**Errata:**  
**PowerWise™ Interface Specification**

**Revision 1.2**

**28<sup>th</sup> January 2005**

## Errata Release Notes

**Figure 5-7. Bus turn-around at the end of a read sequence.**

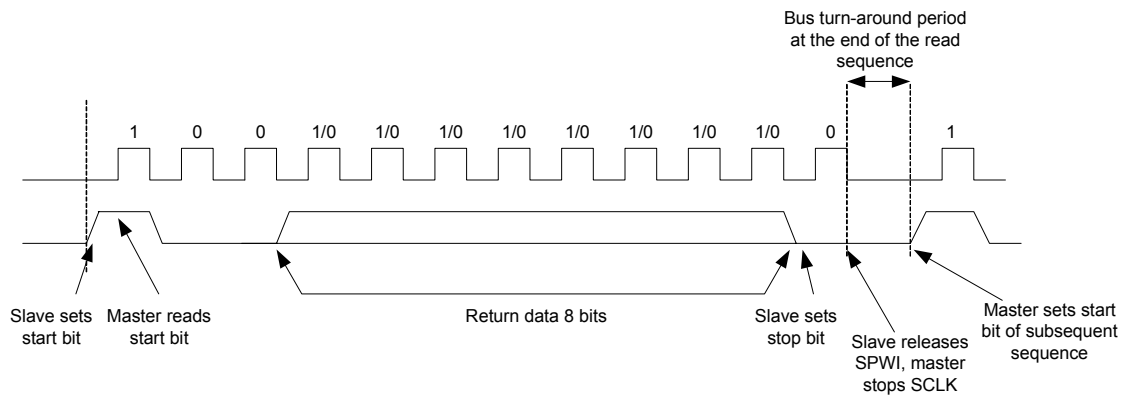
**Background:** The note after figure 5-7 on page 15 in section 5.2.6 can cause misunderstandings.

Figure 5-7 on page 15 correctly shows the first turn-around period between the command and data frames, but does not show explicitly the second turn-around period. The figure below shows the second situation. Please refer to figure 5-7 in PWI 1.0 specification for the complete register read sequence.

**Change:** After the note following figure 5-7 another note is inserted:” Note 2: During the bus turn-around period of the read sequence, after the register read command frame from the PWI master and before the data frame from the PWI slave, the PWI master provides a single clock pulse on the SCLK-line. This clock period starts when PWI master releases SPWI and ends when the PWI slave sets the start bit of the data frame.”

**Figure 7-1. PWI Slave State Diagram**

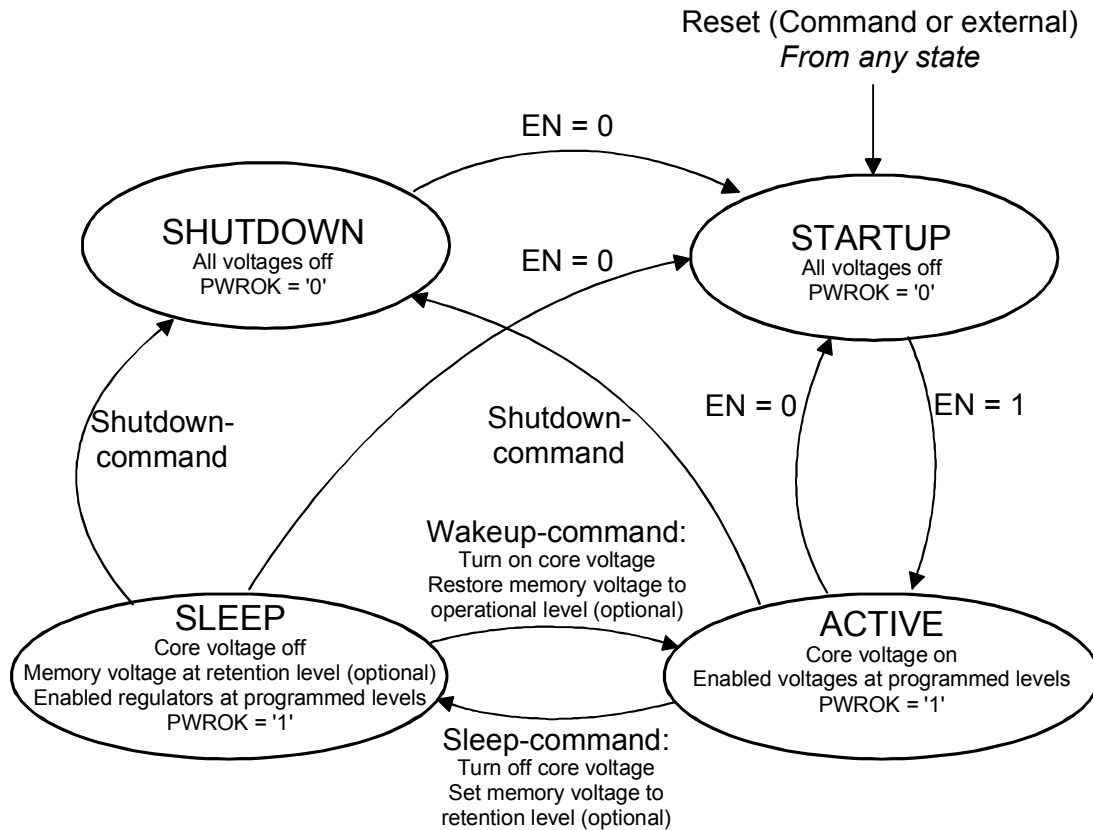
**Background:** The operating state diagram (Figure 7-1.) gives an impression that all voltage regulators have to be on in the active state. However, the PWI specification dictates only the behavior of the core voltage regulator and to some degree the memory voltage regulator (see section 7.2.3 Sleep). Any user registers and / or optional voltage registers controlled by the PWI1.0 may have default voltages that are defined by device manufacturer. The enabling and disabling of optional regulators and user functions upon start-up is defined by device manufacturer.

**Change:** The updated PWI state diagram is shown below.

**Explanation:** Figure 7-1. PWI Slave State Diagram is updated to reflect explicitly those core voltage regulator configuration changes that are mandatory per PWI 1.0 specification. The implementation of a memory voltage regulator and retention voltage are optional EMU features as explained in sections 6.2.2 and 6.2.3 of the PowerWise Interface Specification. The state description text for each state and for Sleep- and Wakeup-commands is updated accordingly.
